DRAFT Minneapolis Park and Recreation Board Southwest LRT DEIS Comment Letter

Re: Minneapolis Park and Recreation Board Comments on the Southwest Transitway Draft Environmental Impact Statement

Park, looking SE from Kenilworth Regional Trail access

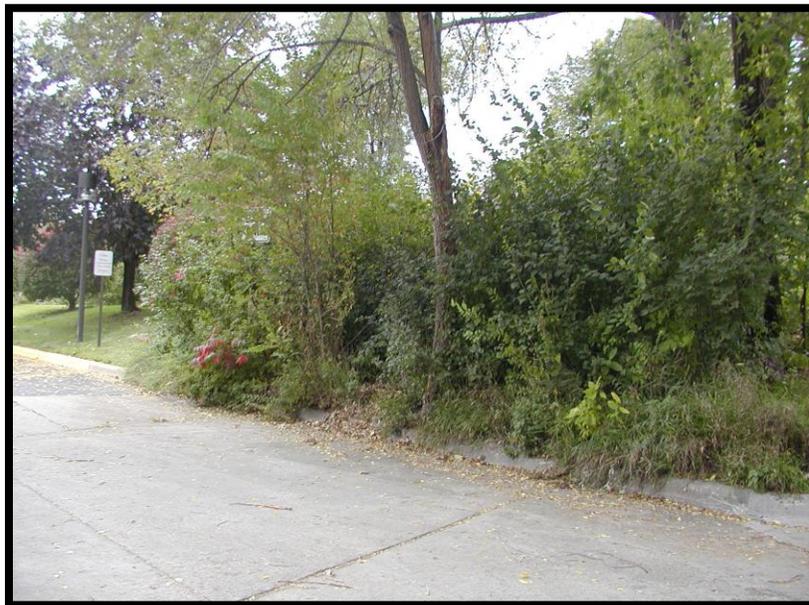
The MPRB is deeply concerned about the impact of LRT noise on Park Siding visitors, especially the very young children who frequent this neighborhood park.

- 4.4.1 **Outcome:** Park users, especially young children, are not subject to LRT noise levels that exceed the noise standards set for Category 1 land uses.

On Cedar Lake Parkway-Grand Rounds; at junction looking SW along Kenilworth Regional Trail; Cedar Lake and beach at right

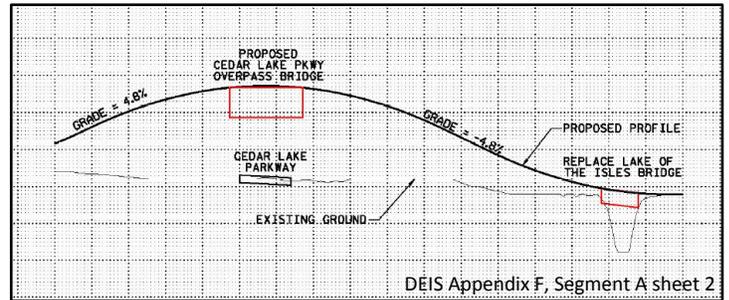
The Minneapolis Park and Recreation Board is concerned that adding LRT into this intersection could result in frequent delays of parkway and trail users along or parallel to Cedar Lake Parkway, and create visual obstructions. The MPRB finds that both of these impacts would significantly diminish the quality of experience for parkway, park, and trail users. Further, such impacts are inconsistent with one of the basic design characteristics of the Grand Rounds: a continuous recreational driving experience.

The anticipated frequency of trains along the corridor will also increase potential conflicts between the trains and users of the trail parallel to Cedar Lake Parkway, thus raising serious safety concerns.

The MPRB is also concerned that the proposal to elevate the LRT above the parkway at this intersection (see side image) will increase noise and create visual impacts that will significantly diminish the quality of experience for parkway, park, and trail users of a property that is eligible for the National Register of Historic Places.

5.2.1 Statement: A preliminary feasibility study of a grade-separated crossing at this intersection revealed that lowering the tracks and trail, and bridging portions of the parkway may allow the train and trail to travel beneath the parkway (see Attachment A for illustration). The MPRB recommends further exploration of this type of integrated solution that significantly reduces hazards to pedestrians, bicyclists, and vehicle drivers; noise impacts; visual impacts; and flow disruptions and delays for motorized and non-motorized vehicles.

5.2.2 Outcome: The Grand Rounds (eligible for National Register of Historic Places) fully retains its integrity and intention.

5.2.3 Outcome: Motorized and nonmotorized vehicles and pedestrians along the trail parallel to Cedar Lake Parkway experience continuous and safe flow.

From Kenilworth Regional Trail looking along Kenilworth Channel

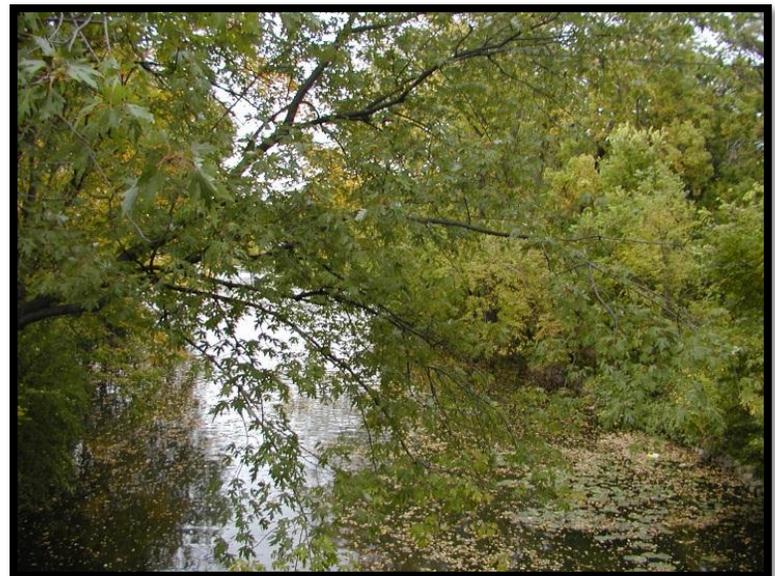
The MPRB is concerned about preserving the historic character of the 1913 Kenilworth Channel in its critical role within the Minneapolis Chain of Lakes Regional Park.

According to the DEIS (3.6.3.3) ...the bridge design, bank treatment, and aesthetics for the new facility and the potential replacement or modification of the existing pedestrian bridge would have a substantial effect on this historic landscape... In addition, (3.4.5.3) ...Potential long-term effects may occur at the following properties: Kenilworth Lagoon/Channel, Grand Rounds (potential effects of the construction of new bridge structures within the historic district; the design and footprint of these structures may affect the banks of the historic channel and may affect the district's overall feeling and setting).

6.2.1 **Outcome:** Support and safety structures are harmonious, beautiful, and both historically and context

6.2.2 **Outcome:** The Kenilworth Channel retains its natural beauty and serenity and historic character.

Luce Line Regional Trail crossing to connect with the Cedar Lake Regional Trail

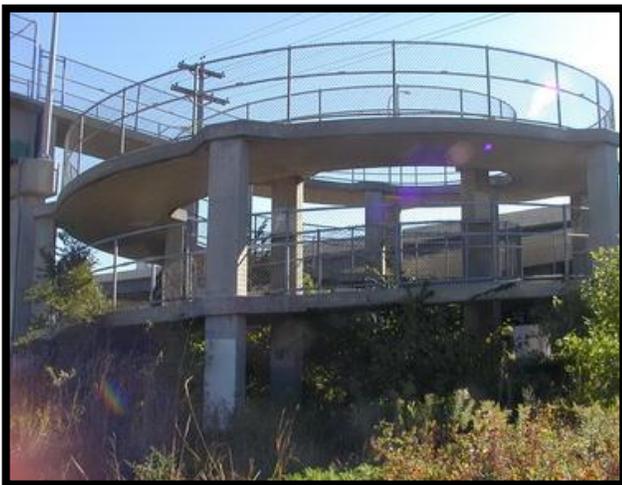
11.2.2 **Outcome:** Bicyclists in this area maintain continuous flow and speed.
